AMENDMENT NO. 2 FEBRUARY 2018
TO
IS 15804 : 2008 AUTOMOTIVE VEHICLES — WINDSCREEN WIPING AND
WASHING SYSTEM FOR M1 CATEGORY OF VEHICLES — REQUIREMENTS

FIG. 5 VISION AREA B

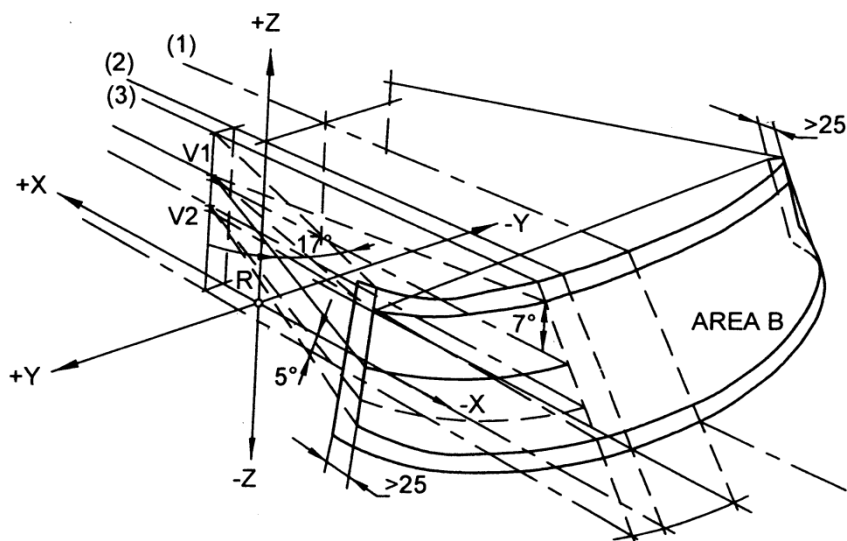
(Page 10, Annex B, Fig. 5) — Substitute the following figure for the existing figure:

- 1) LINE TRACING THE MEDIAN LONGITUDINAL PLANE OF VEHICLE.
- 2) LINE TRACING THE LONGITUDINAL PLANE PASSING THROUGH R
- 3) LINE TRACING THE LONGITUDINAL PLANE PASSING THROUGH V₁ AND V₂
